PROJECT: Summitlin West Village 25-Sandstone Rise Dr (Street M)

CITY OF LAS VEGAS		DATE:
INTER-OFFICE MEMORANDUM		February 16, 2021
TO: Land Development Services Department of Building & Safety		FROM: Albert Sung, P.E. Flood Control Project Engineer Department of Public Works
SUBJECT:	Drainage Study for:	
	Summerlin West Village 25 - Sandstone Rise Dr. (Street M) (from Park Drift Trail <Street K> to Sky Vista Drive) – Update #1	
Cross Streets:	NWQ of Sky Vista Drive & Far Hills Avenue	
File Number:	F:\Depot\DSMemos\DS5221D.doc	
Parcel Number:	137-21-801-001, 137-22-301-001	
Zoning Action:	N/A	
FEMA Flood Zone	YES	NO X
Proposed Storm Drain	YES X	NO
COPIES TO:		Atkins
		Howard Hughes Company LLC
		Bart Anderson, P.E., DevCo
		CCRFC

Update #1 to the Technical Drainage Study
for

Sandstone Rise Drive (Street M): Park Drift Trail
(Street K) to Sky Vista Drive

B.1 Figure 4 Hydraulic Workmap

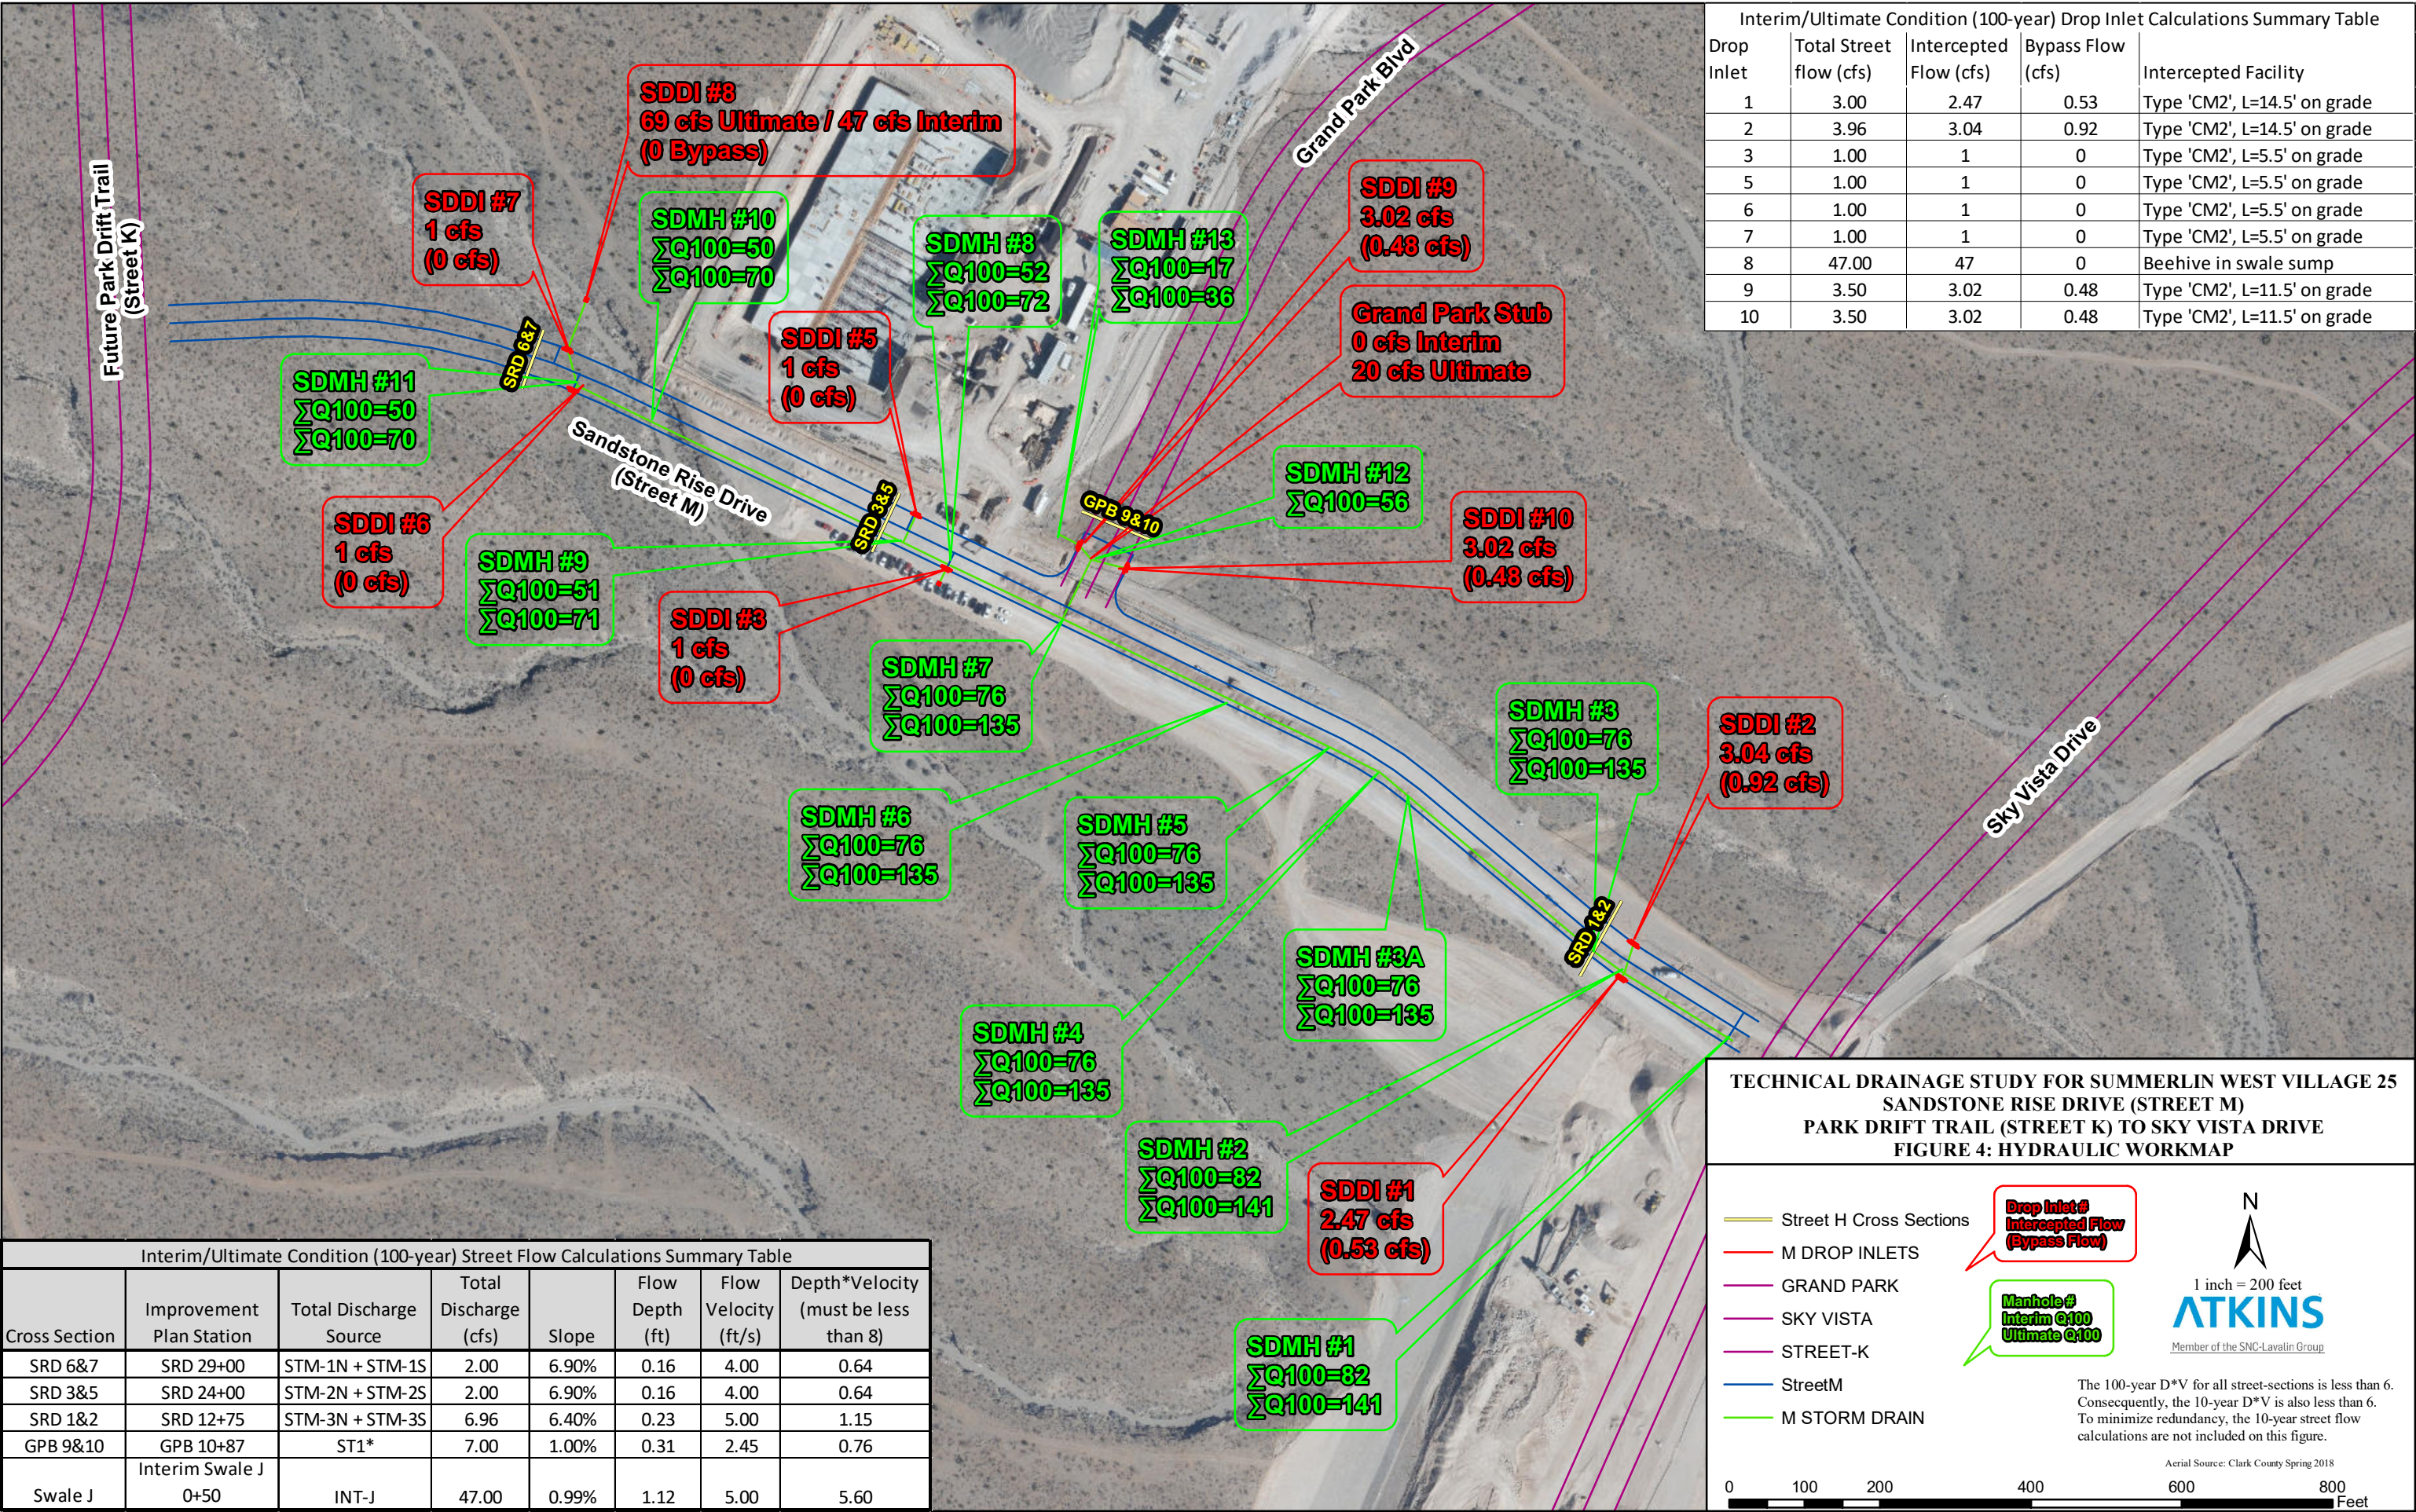
Comment #5: *Figure 3 Hydrology Workmap* also did not state what drainage condition it is trying to present. Is it an *Interim Condition* or *Ultimate Condition*? Label clearly in the next submittal

The revised workmap still did not state whether it is *Interim* or *Ultimate* condition. Provide a corrected workmap as a supplement to *City Flood Control*.

Comment response: The Hydrology Workmap label has been revised to indicate the Interim Condition. The Ultimate Condition is presented in the Village 25 Master Drainage Study
